Rezoning Transportation Analysis

Petition Number: #2022-048

General Review Information

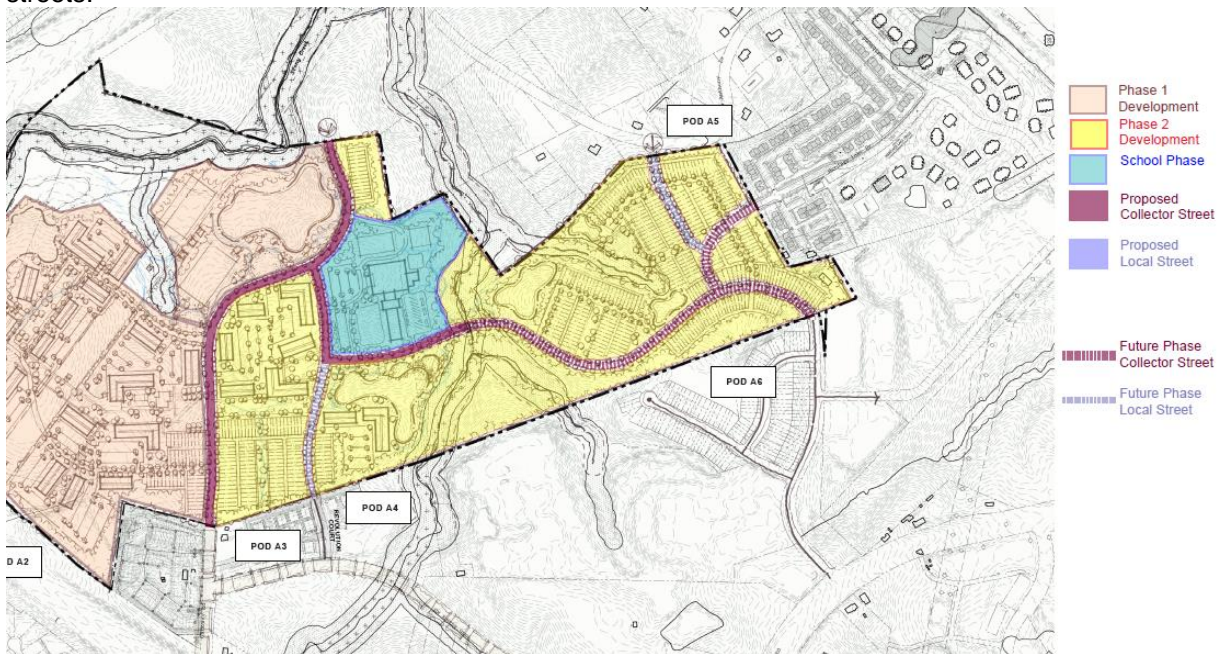
~~3. Outstanding Comment from 08-25-22:~~ Revise site plan and conditional note(s) to commit to improving the existing Galloway Road stub to John Adams to the local collector street typical section per U-07.

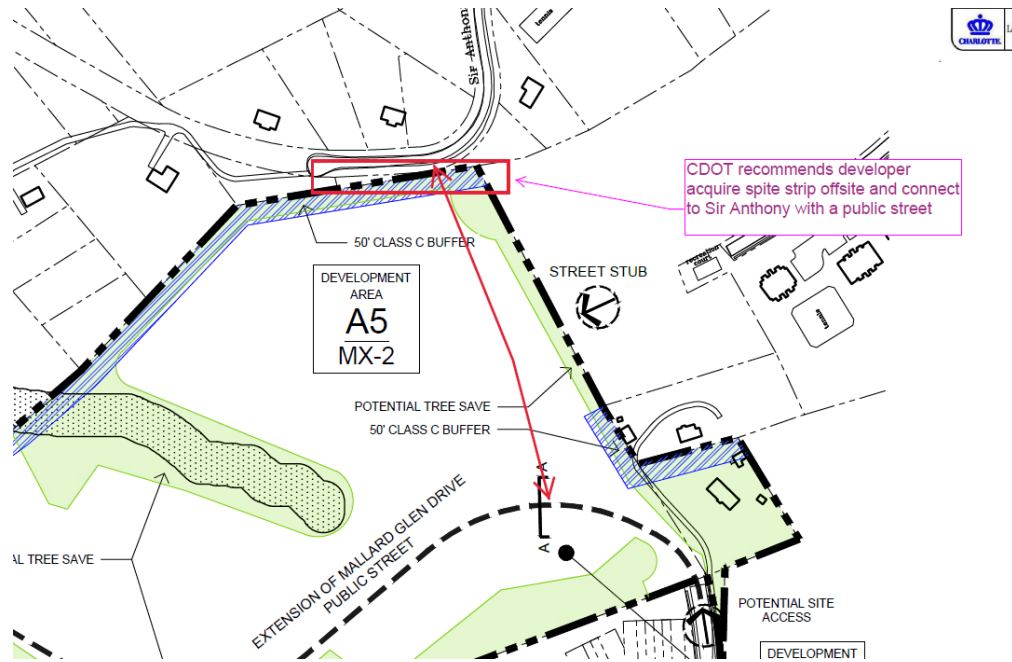
- ~~5. Add conditional Lighting Note for petitioner to coordinate with CDOT Lighting, Bruce Horltd (704-589-5836 or Bruce.Horltd@charlottenc.gov), prior to permitting of lighting fixtures on public roadways.~~
- ~~6. **CDOT RECOMMENDATION:** CDOT recommends the petitioner commit to providing a public street connection to Sir Anthony Drive.~~
